## The Cornerstone Project

# 97-101 NEWBURY St. – FRONT ENTRY LANDSCAPE BACK BAY ARCHITECTURAL COMMISSION

01 / 11 / 2023

NEHGS Summary of Revisions to Landscape Design November 1, 2022

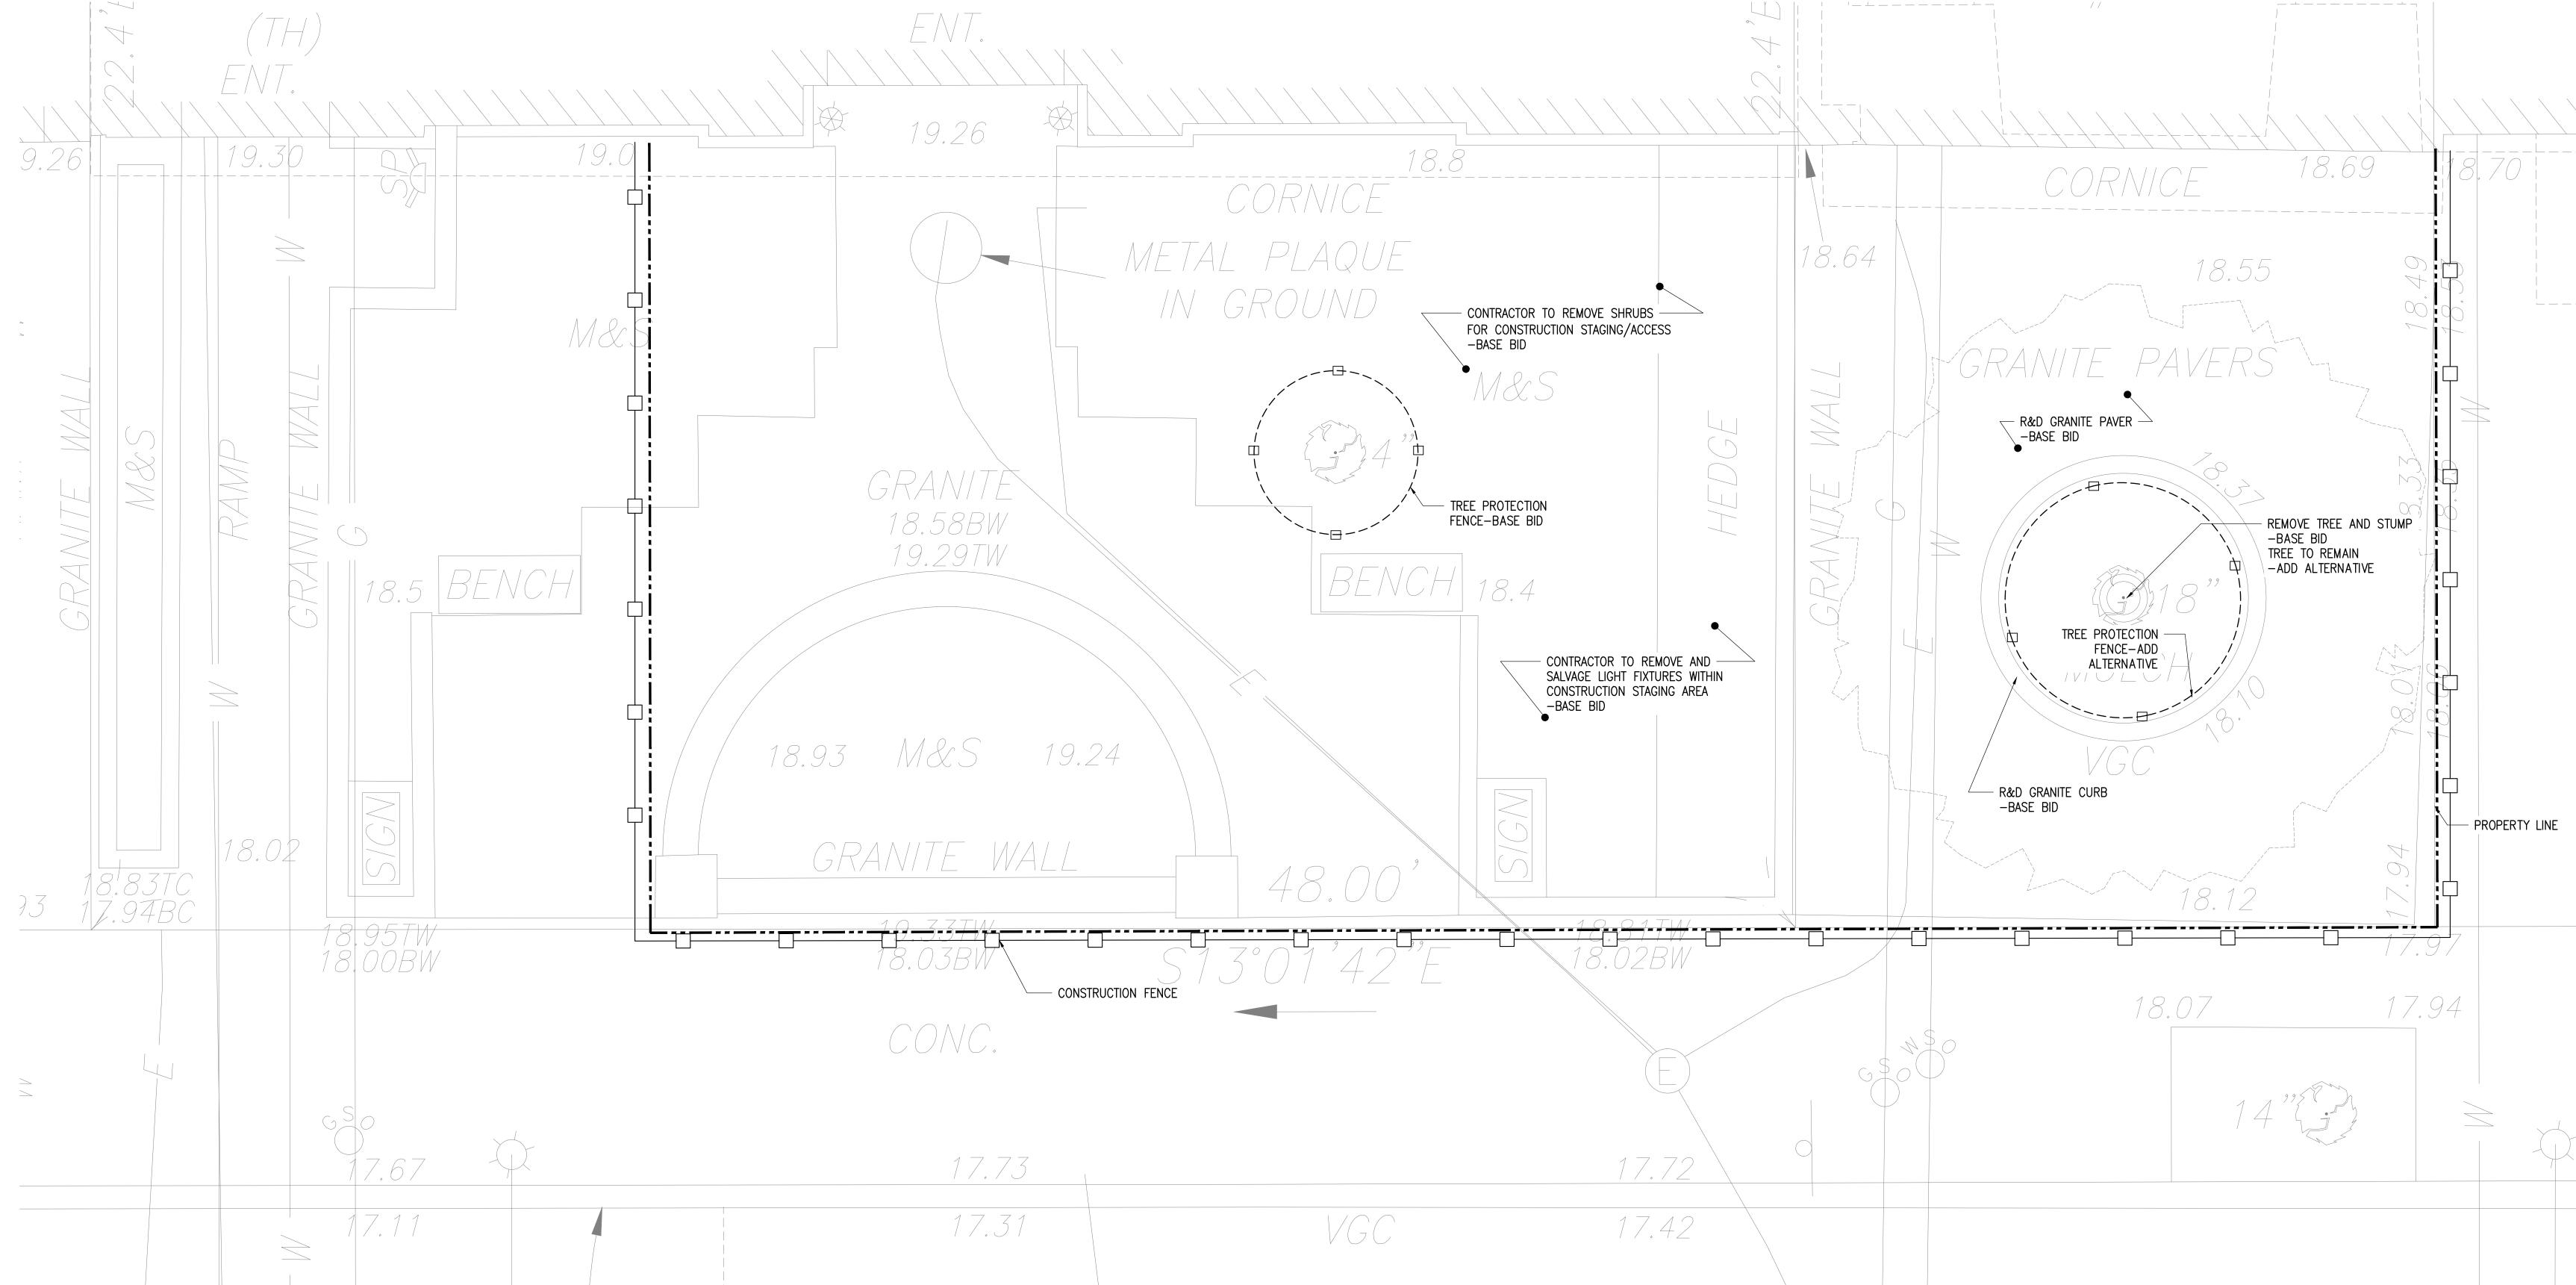
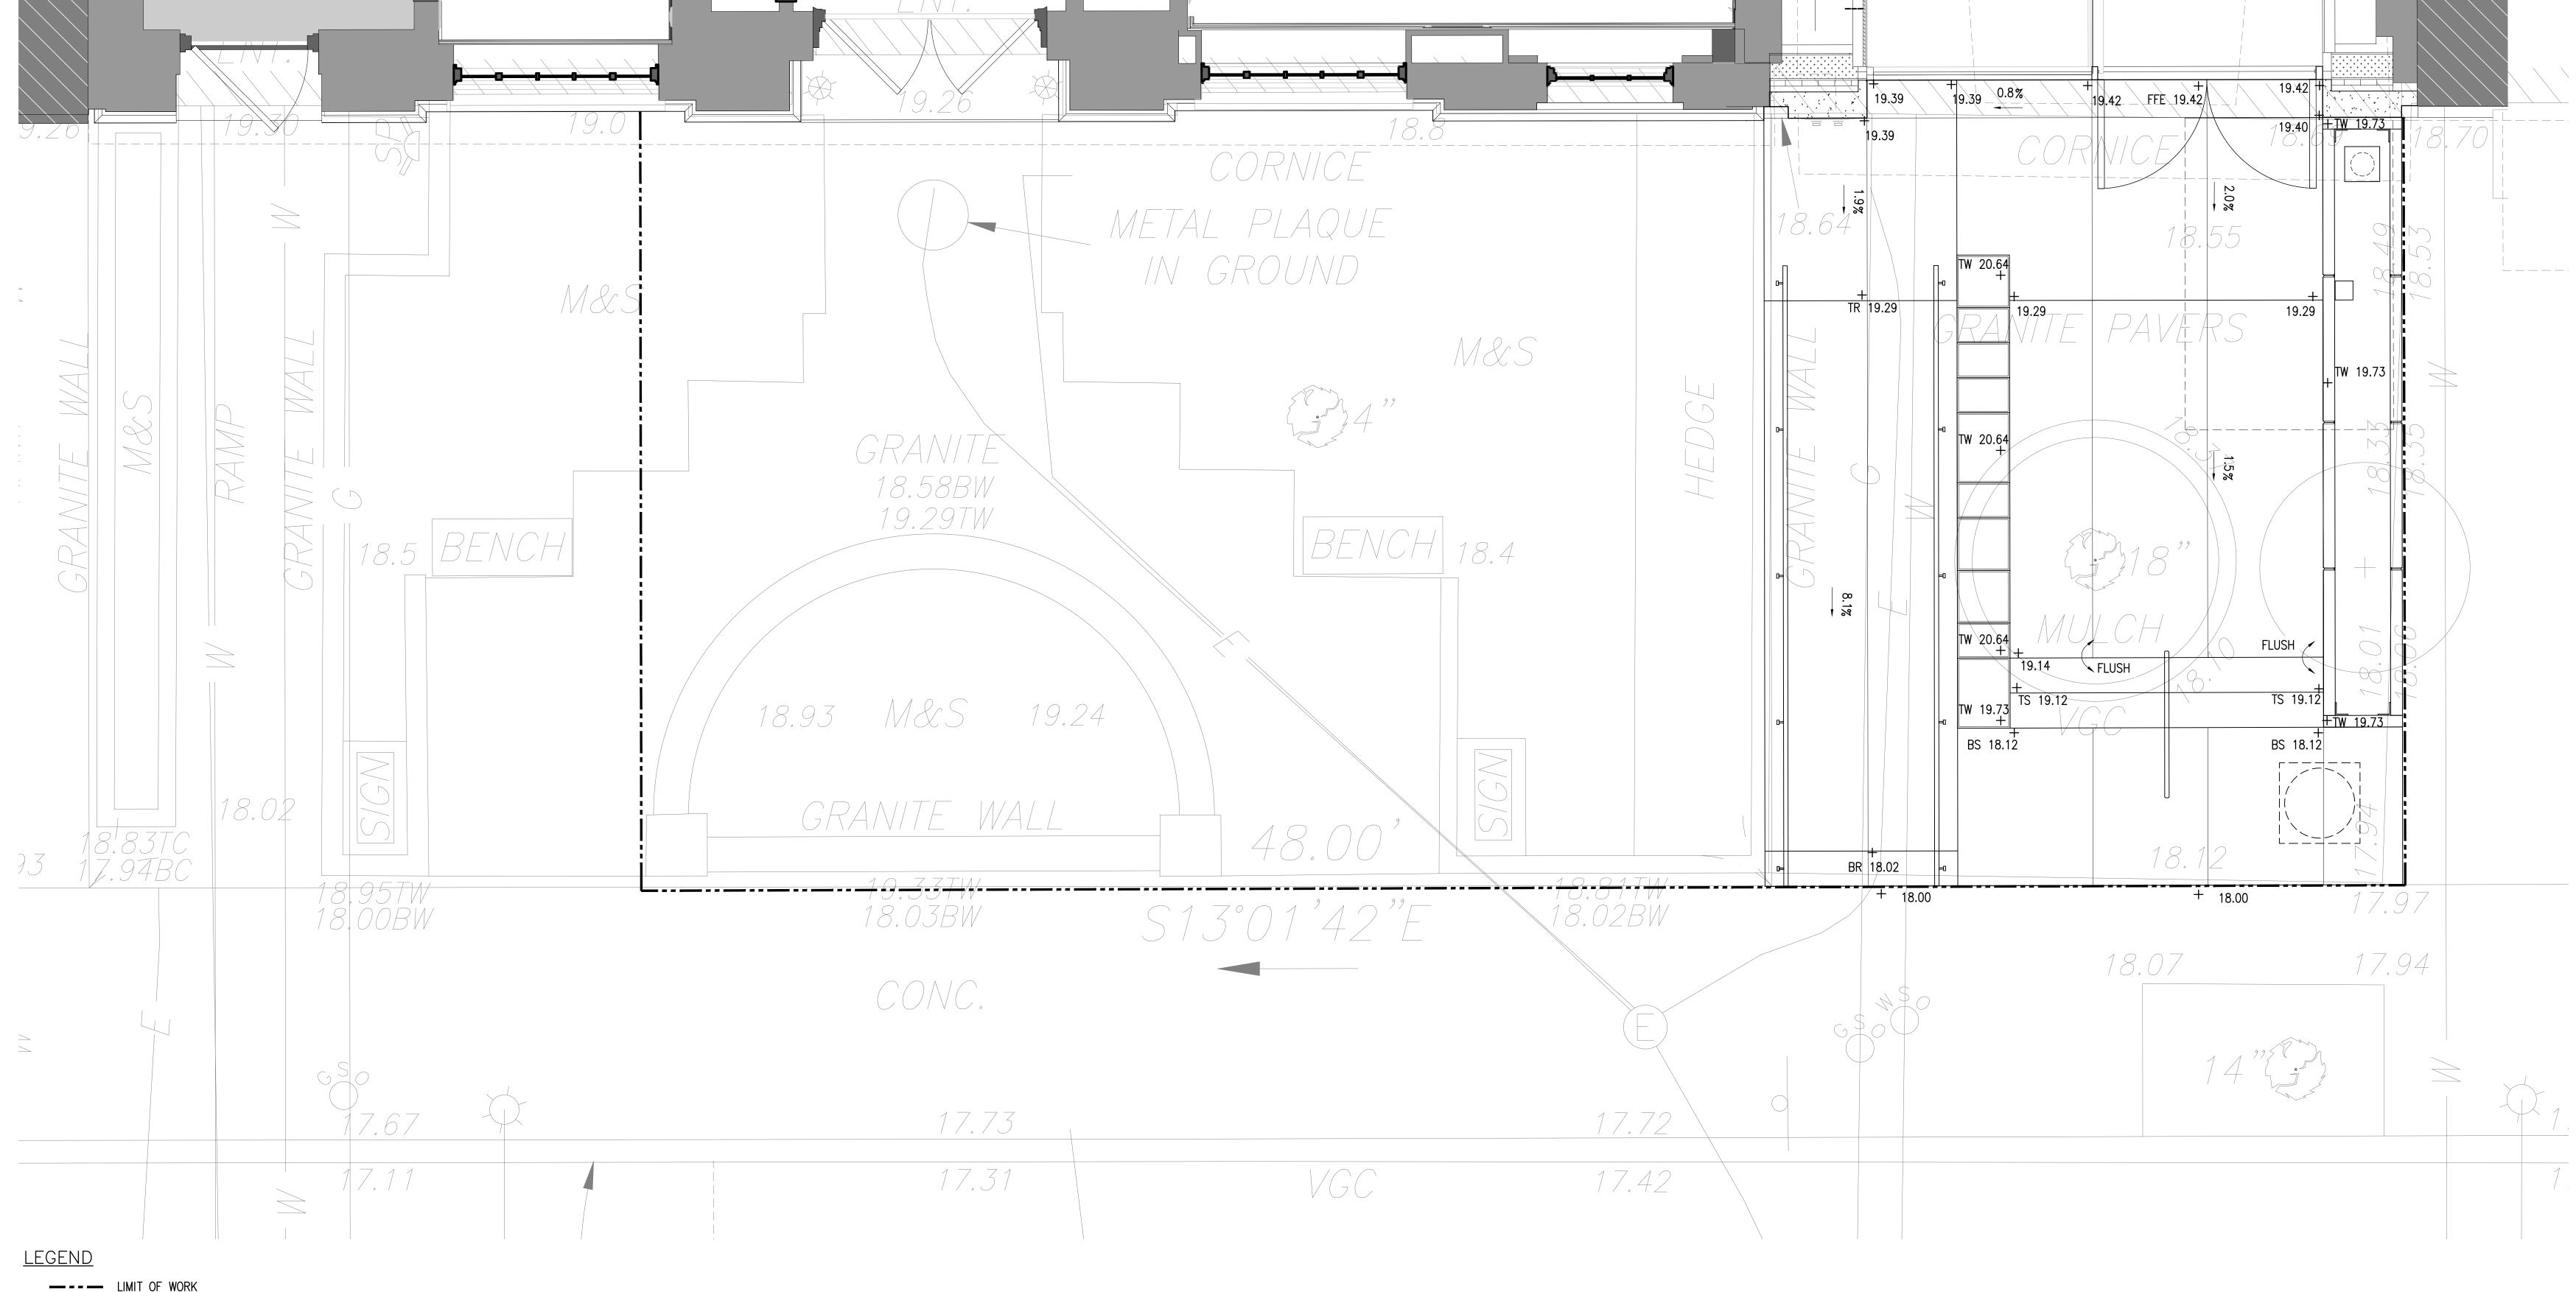
Our original landscape design for the entry to 99 Newbury Street included a sloped plaza with a seat wall retaining the grade along the east property line. We have determined since our submittal to BLC, that landscape design did not account for the proper finished floor elevation, and with further review, did not meet ADA and MAAB guidelines for an accessible route.

We are now submitting a revised design that accounts for the proper floor elevation (19.42') and provides an accessible route from the public way to the entry with an accessible ramp.

This revised design includes an accessible ramp with handrails along the west property line, stairs (with 2 risers and a handrail) leading from the sidewalk to building entry, a seat wall retaining the grade between the ramp and plaza, and a planter retaining the grade along the east property line.

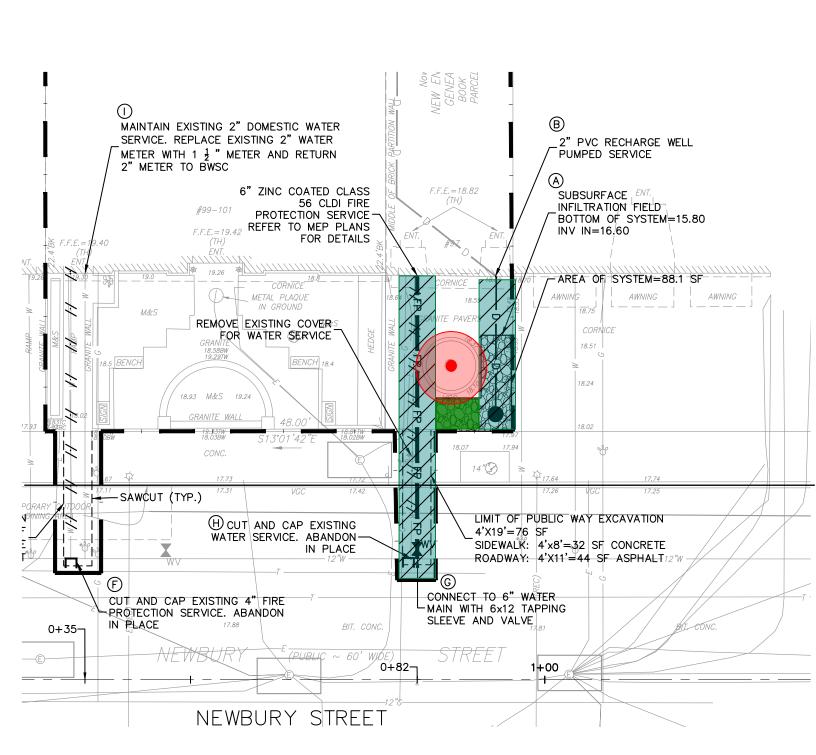
The drawing below illustrates the Code required excavation around the existing tree at 97 Newbury Street. The red zone is the expected root ball, the green shading shows the width of the trench for the utilities being installed.

New Fire Service line trench is 4' deep and will have the most impact to the root ball. This needs to be installed in this location because it is an increase in size from existing and it aligns with the new fire pump in the building.

New drain line and stone infiltration is mandated for ground water recharge per Boston Water and Sewer. This area is three feet deep,filled with stone and a new drainage pipe.
